Inspection Report for North Sturbridge Road Solar Facility

NPDES ID No.: MAR10031G

Inspection Date: 09/17/2021

**FIGURE 1:
SWPPP
INSPECTION
SKETCH
9/02/2021**

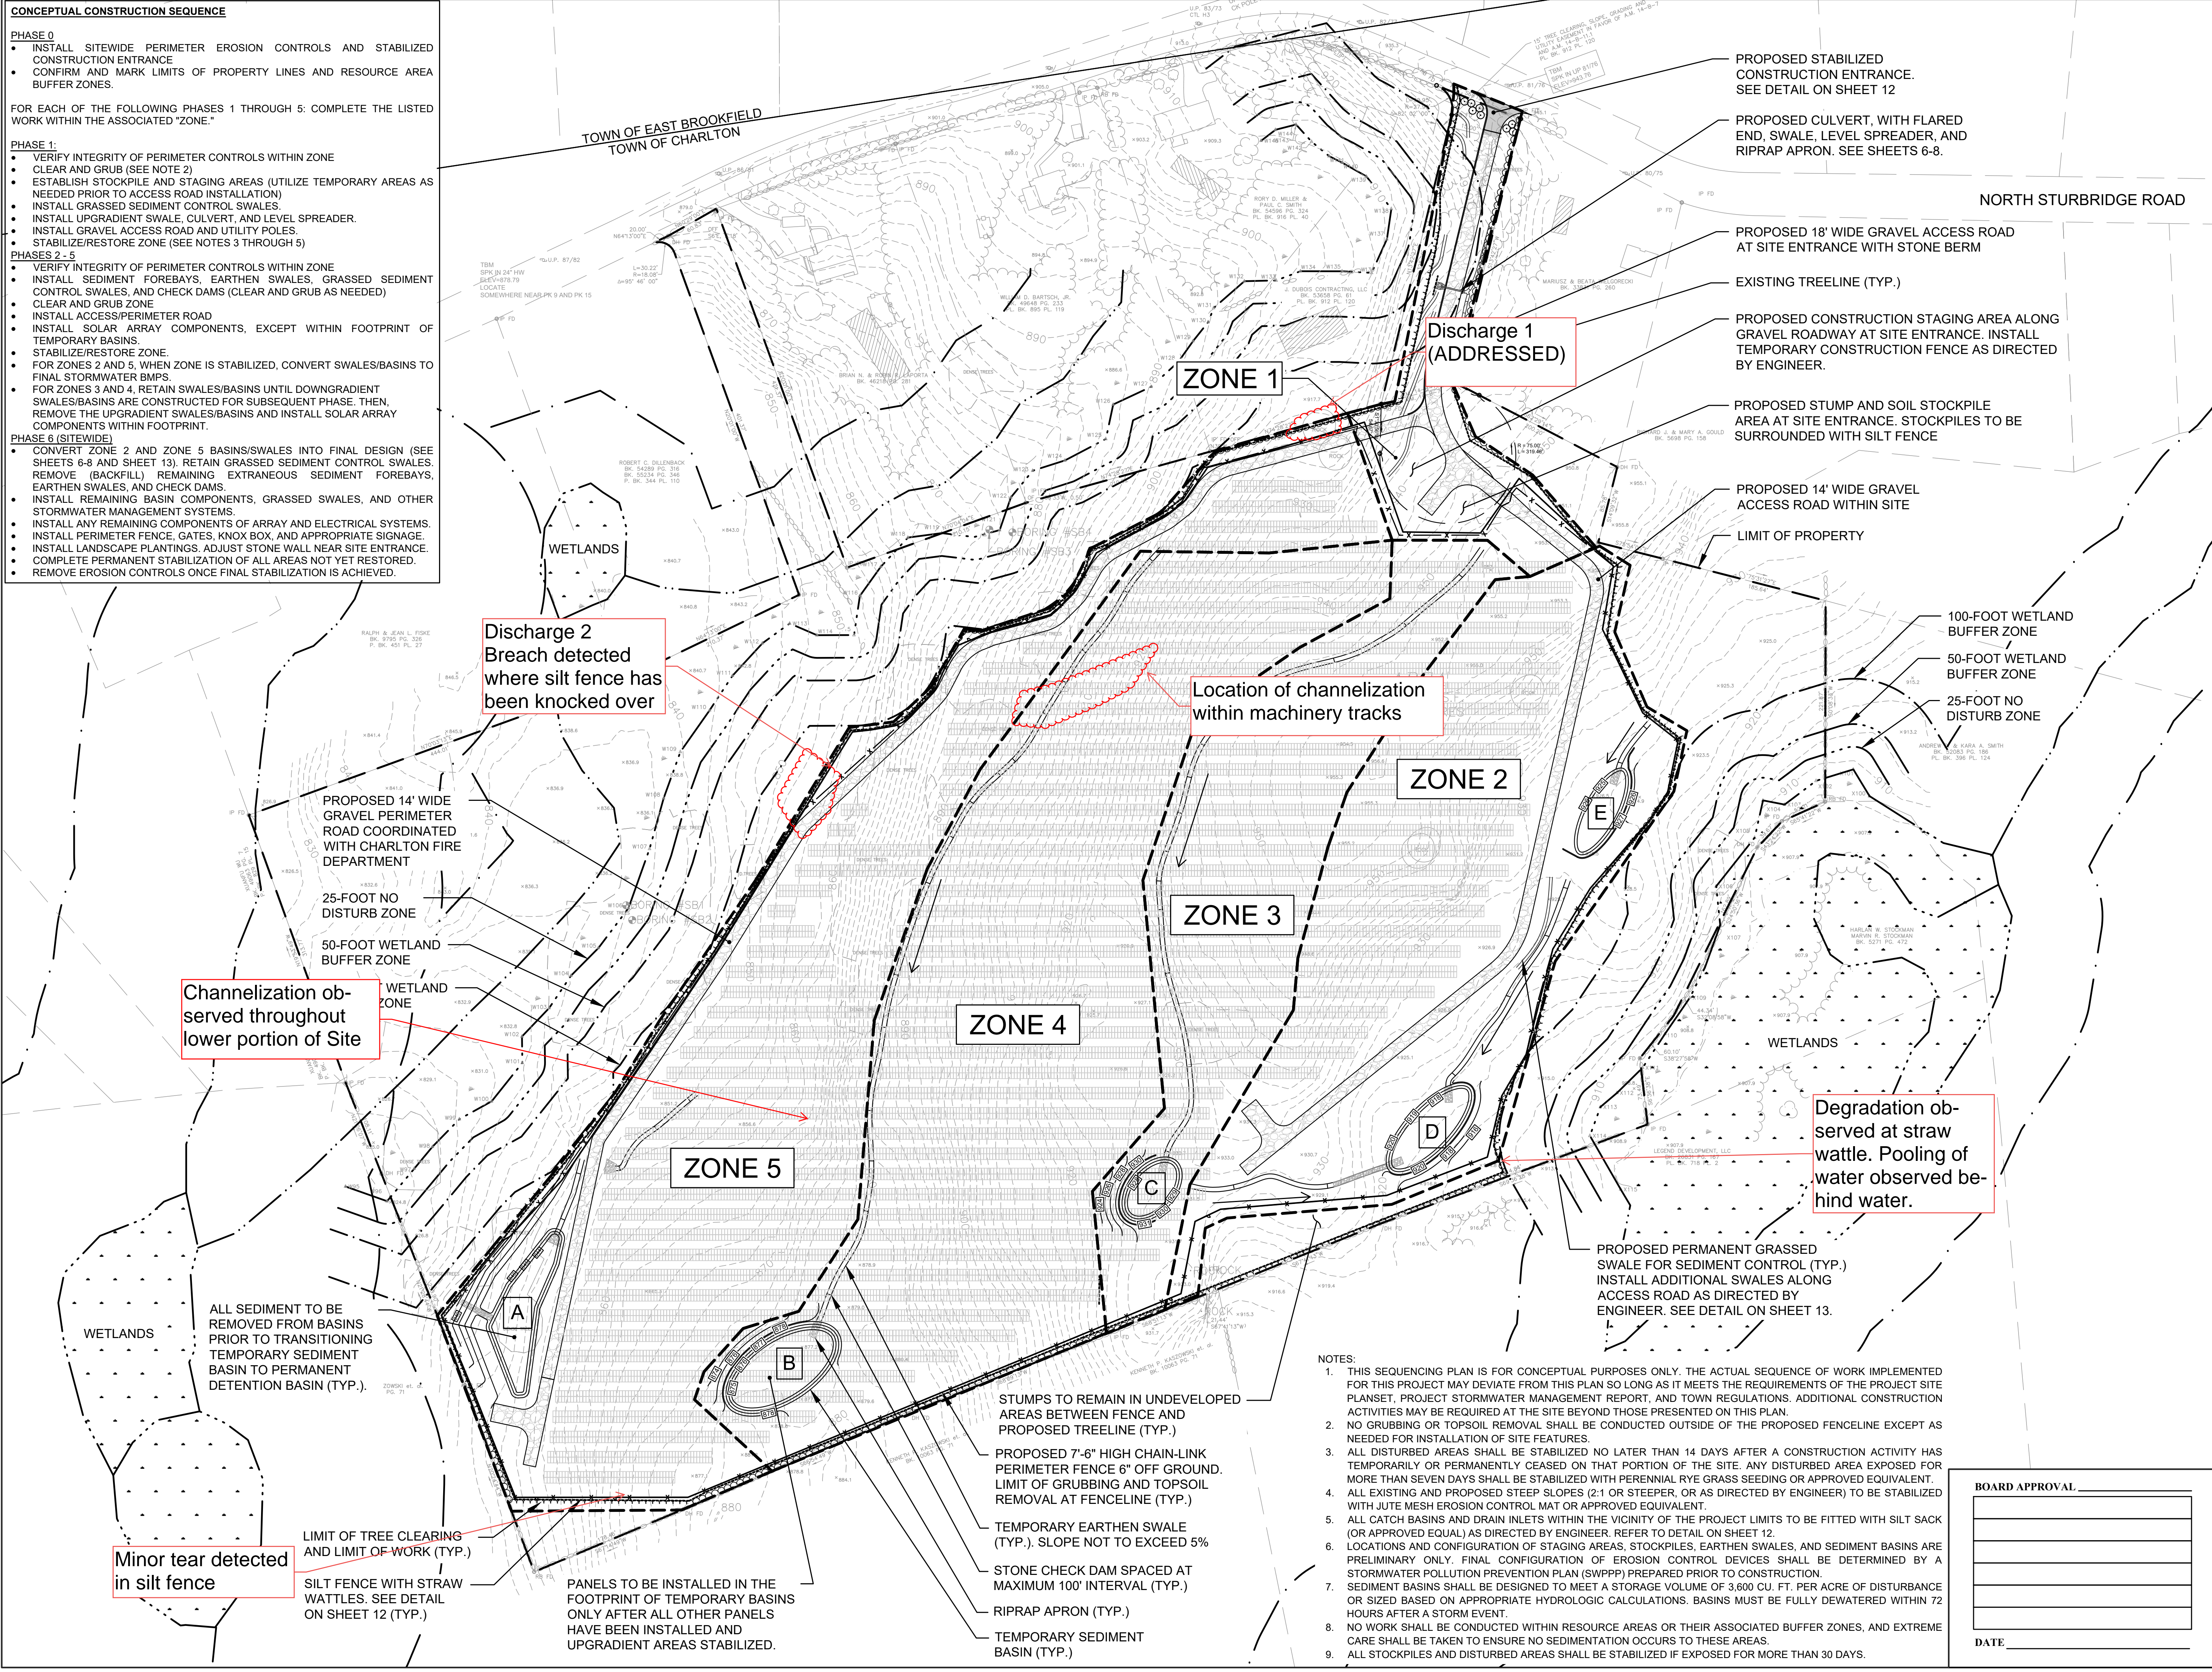
2. Informal access road along northern portion of the Site	Straw mulch or hydroseed	<input type="checkbox"/> Yes [Enter date] <input checked="" type="checkbox"/> No	Erosion channels are beginning to form within upgradient portions of the informal access road (Figure 1). The contractor indicated that stabilization by smoothing out soils and seeding or spreading mulch would occur on 7/30/2021. Stabilization of this area has not been initiated. After inspection of the area on 8/24/2021, it was determined that

Discharge 2
Breach detected where silt fence has been knocked over

Location of channelization within machinery tracks

Channelization observed throughout lower portion of Site

Degradation observed at straw wattle. Pooling of water observed behind water.

Minor tear detected in silt fence
